Determination 2021/018

Regarding the compliance of a pool with Building Code Clause F4 Safety from falling at 100 Awatere Ave, Hamilton

Figure 2: Sketch of pool area (Not to scale)

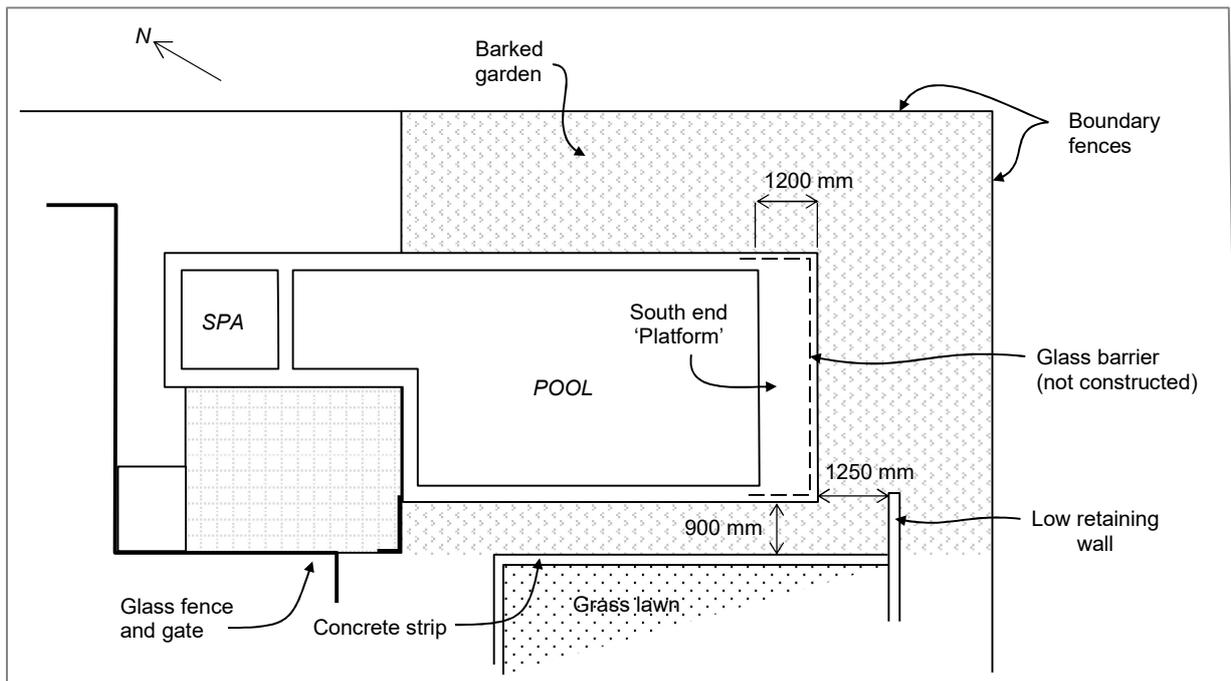
- 2.3 The building consent that was granted for the pool (No. 2018/38563) included a 900 mm high glass barrier around the platform at the south end (refer to Figure 2). The barrier was not installed during construction.

- 2.4 There is a low retaining wall 1250 mm from the pool at the south west corner, and bark gardens around three sides (east, west and south) – see Figures 2 and 3. A small concrete strip bordering a grass area runs parallel to the west side of the pool at a distance of 900 mm from the pool wall.

5.1.4 There is no dispute that people could fall 1000 mm or more from the platform, which is 1200 mm high. As constructed without a barrier the platform does not comply with Clause F4.3.1.

- 5.2.13 I do not consider that there are compelling reasons for a waiver or modification of Clause F4.3.1 to be granted with respect to the lack of a barrier at the south end of the pool.

- 6.1 In accordance with section 188 of the Building Act 2004 I determine that the authority was correct to refuse to issue the code compliance certificate on the basis that the platform does not comply with Clause F4.3.1 of the Building Code, and I confirm that decision.
